Application No. G10904
 Permit No. G10148
 Certificate No. 61759

STATE OF OREGON
COUNTY OF YAMHILL
CERTIFICATE OF WATER RIGHT

confirms the right to use the waters of WELLS 5 AND 6 in the WILLAMETTE RIVER BASIN for the purpose of MUNICIPAL USE.

REFERENCE: File G-10904 - City of Dundee

Application No. G-10904
Permit No. G10148

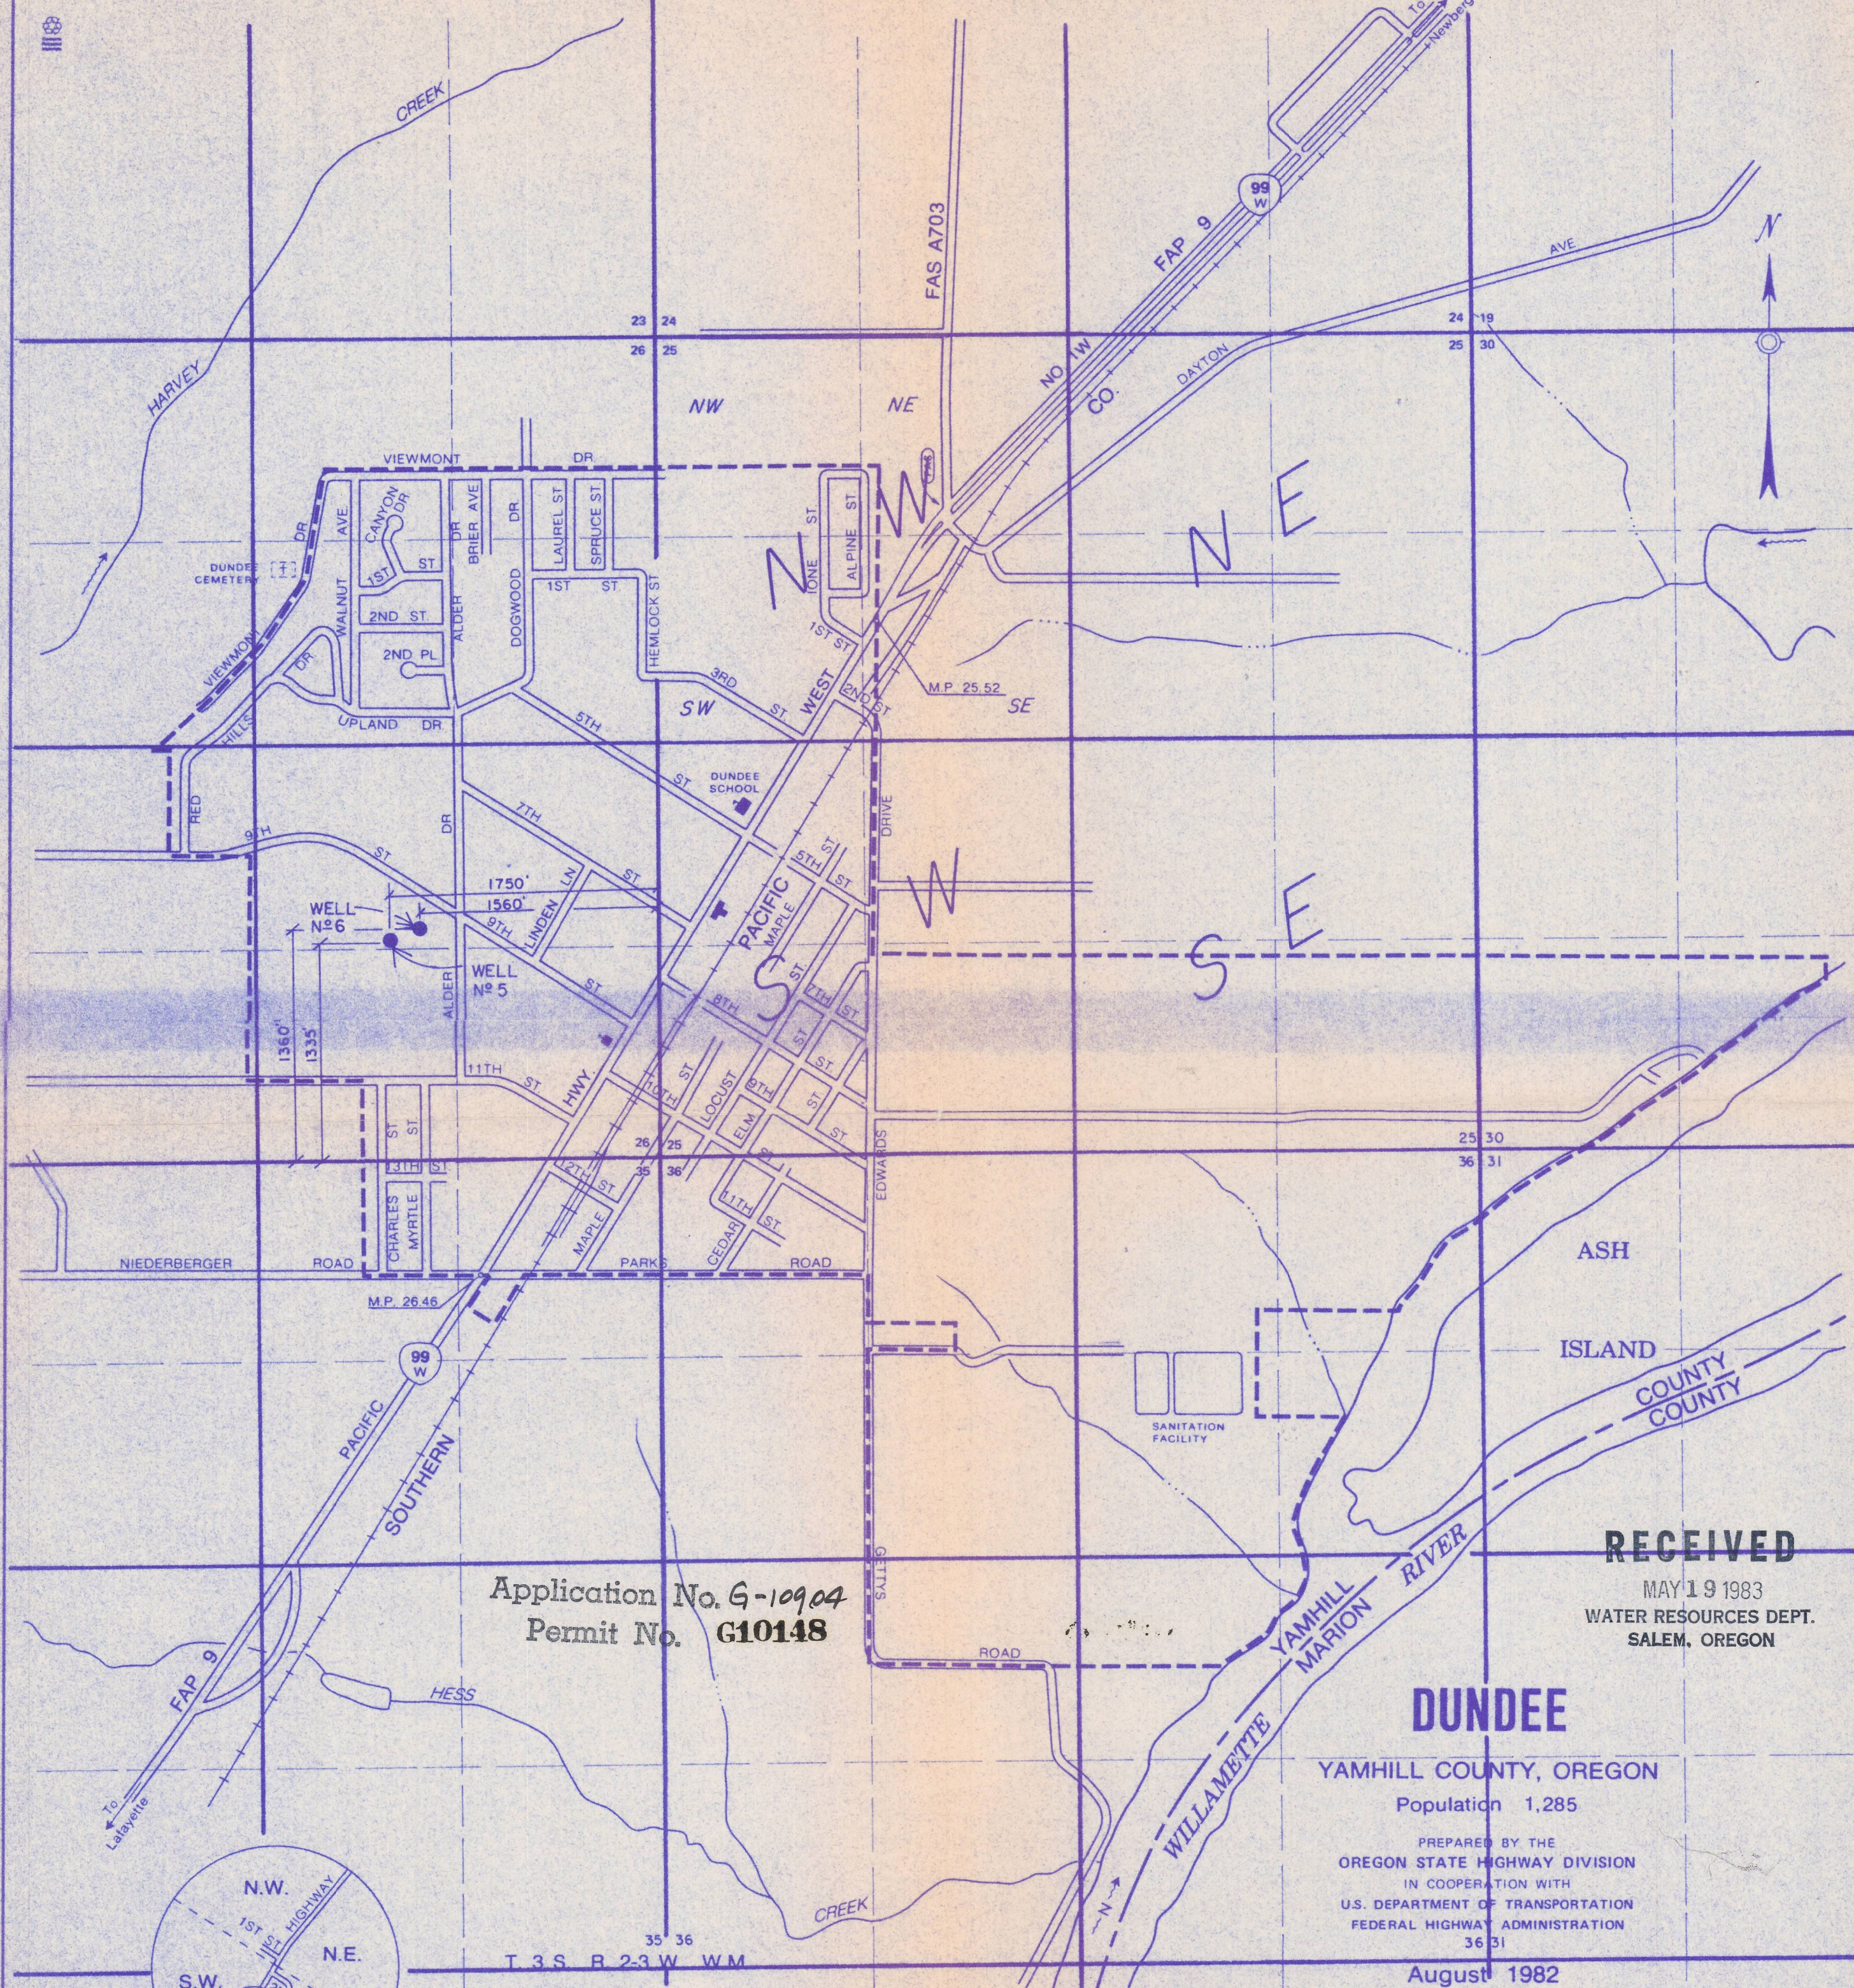
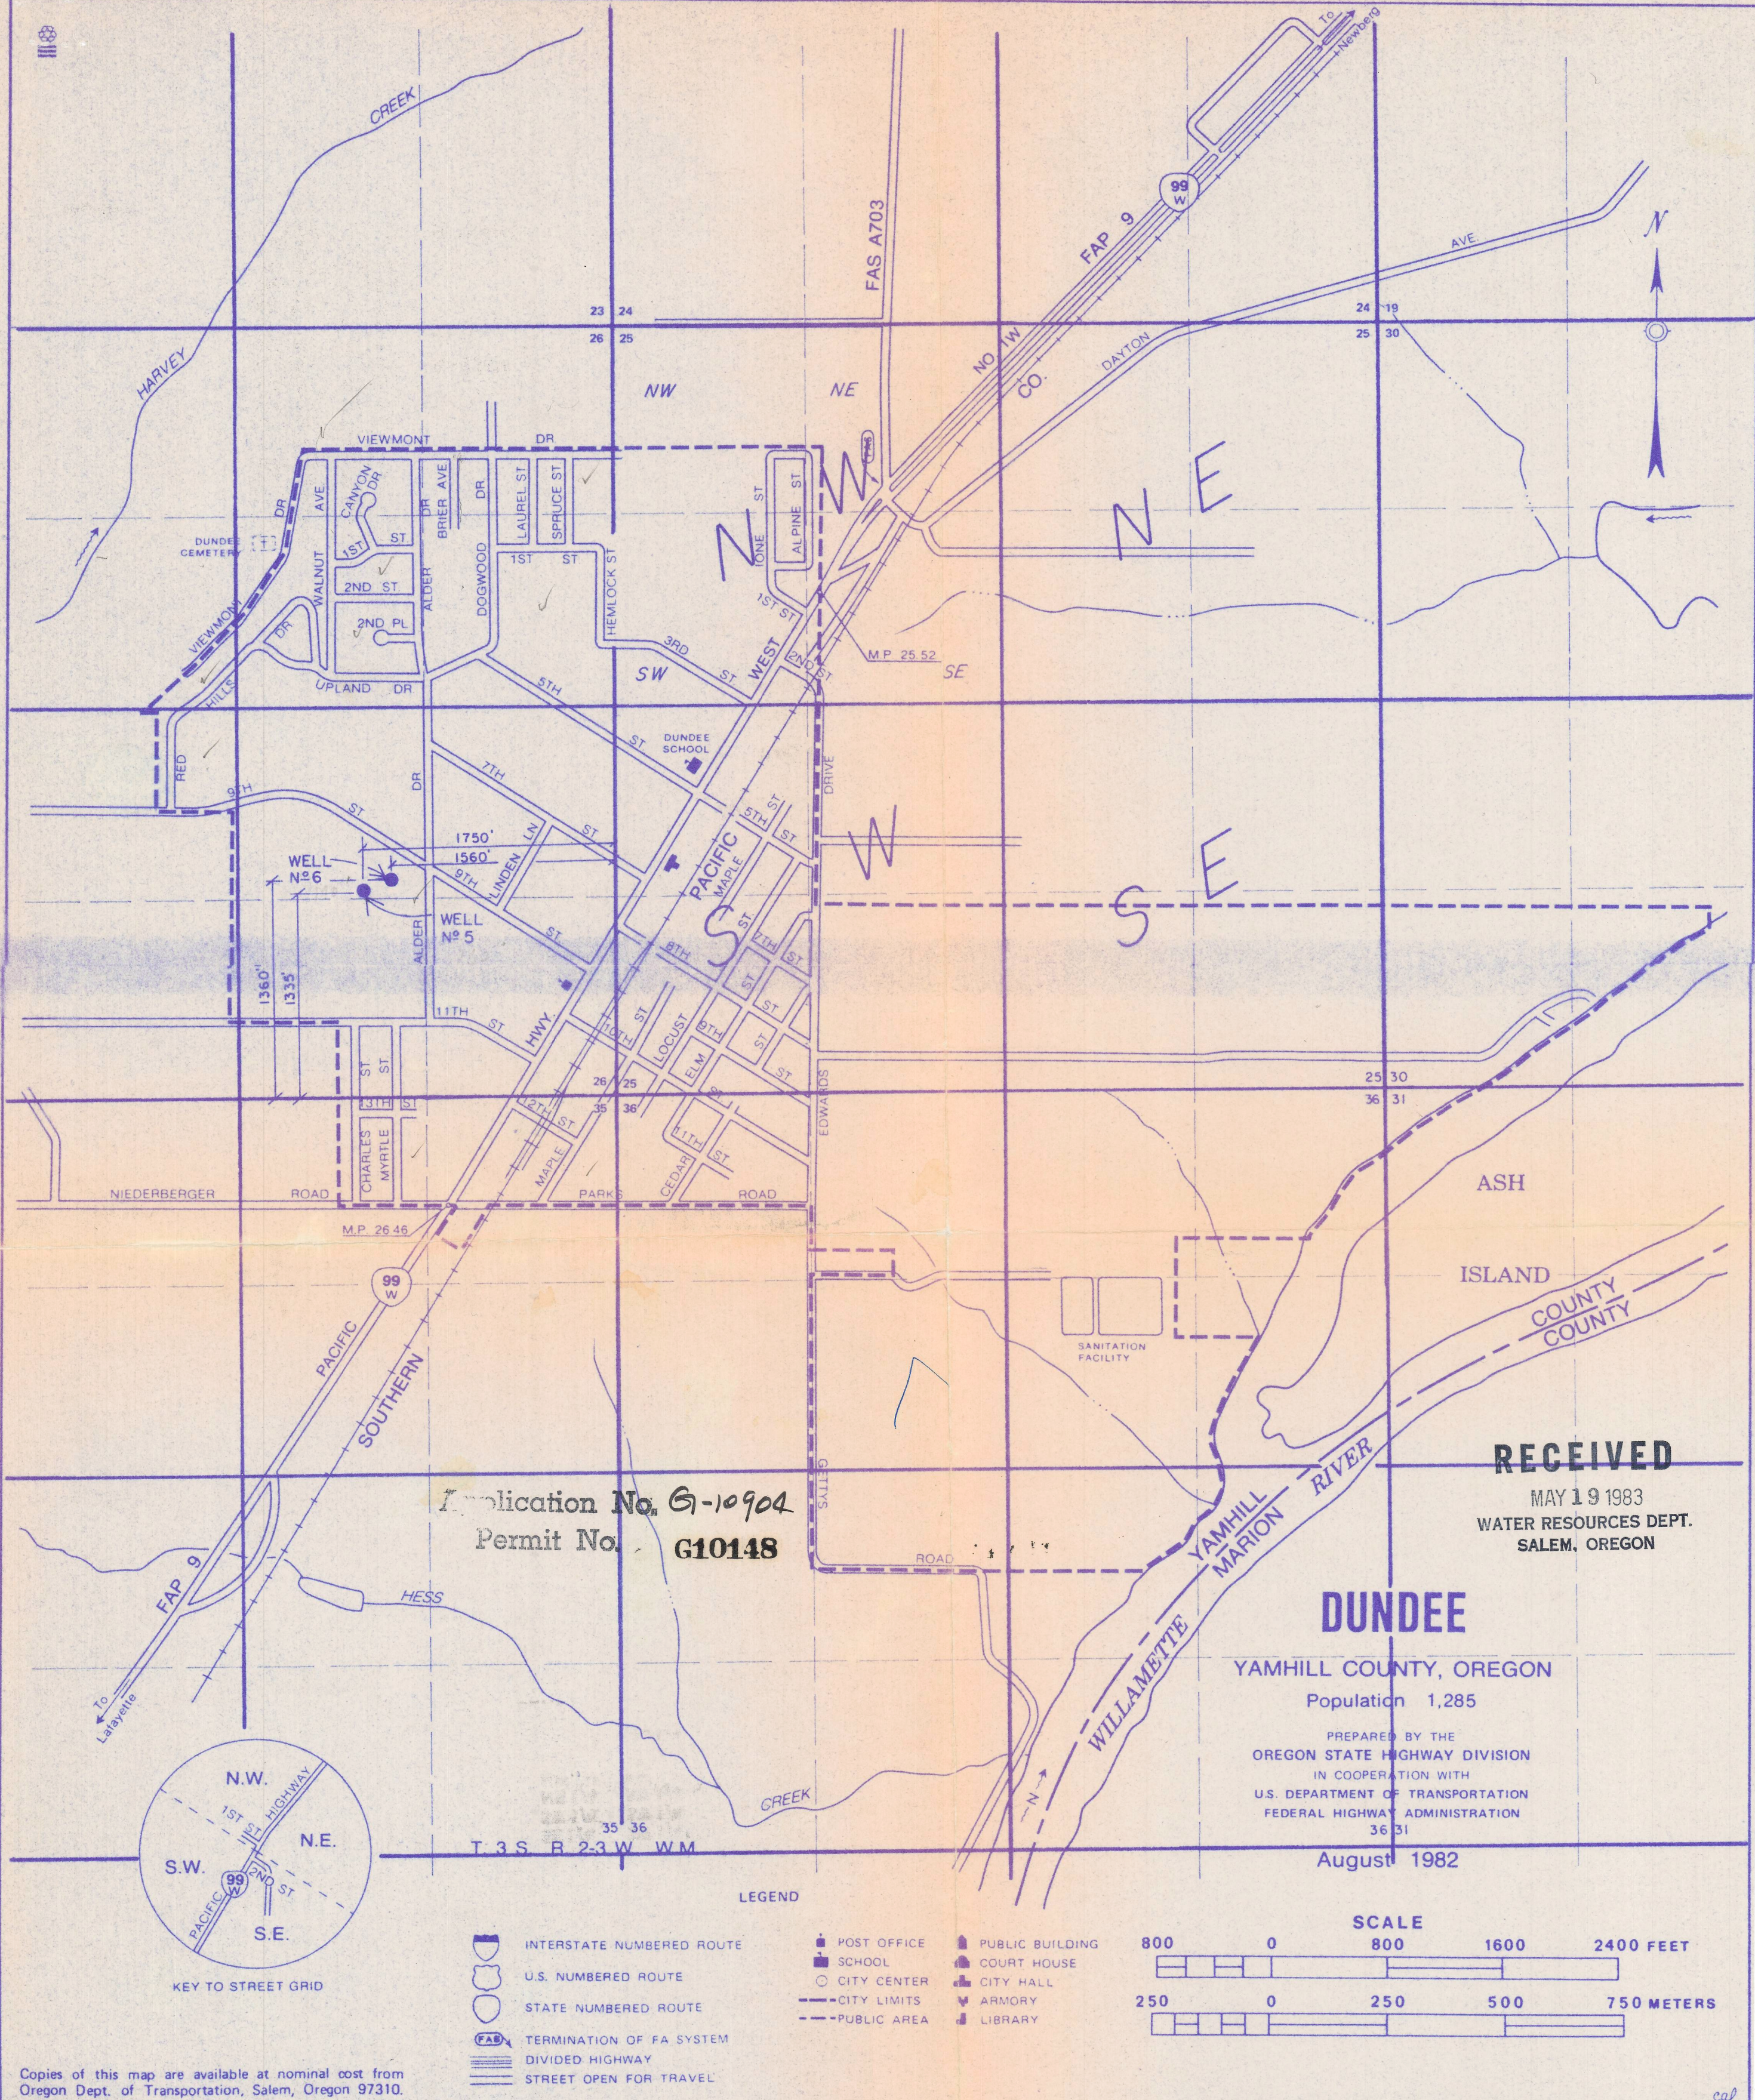
Not all the corrections asked for in my last letter were made. The map show the wells to be located in the NW $\frac{1}{4}$ SE $\frac{1}{4}$ of Section 26. This does not agree with the location of the wells as listed in item 2 of the application. Please amend item 2 of the application to locate the wells in the correct $\frac{1}{4}$ $\frac{1}{4}$ Section.

According to the locations of the wells from the SE Corner of Section 26 as stated in Item 2 of the application, they should both be within the NW 1/4 SE 1/4 of Section 26. However, the application lists them in the NE 1/4 SE 1/4 and the maps show them to be in the NW 1/4 SE 1/4 and SW 1/4 SE 1/4. Please amend Item 2 of the application and the maps to correctly locate the wells within the correct quarter-quarter section.

It appears from the maps that the entire NE 1/4 of Section 26 should be included as a place of use in Item 3 of the application. However, it appears that the NW 1/4 NE 1/4 was left out of the list. Please amend Item 3 of the application to include the NW 1/4 NE 1/4 of Section 26 as a place of use.

The maps submitted are not to a standard even Engineer's scale and are not acceptable for our purposes. Please submit a map to a standard even scale of not less than 4" = 1 mile. If the map is larger than 11" x 17", four copies are required. Please state the locations of the wells and scale of the maps on the maps.

The wells, as shown on the maps, are located in Range 3 West. Please amend Item 2 of the application to state R3W for the location of the well.

It appears from the map, when comparing the location of the place of use (I am assuming that this is within the dashed line) with Item 3 of the application that not all quarter-quarter sections are listed and some which are listed are not needed. Please amend Item 3 and/or the map to correctly locate the place of use.
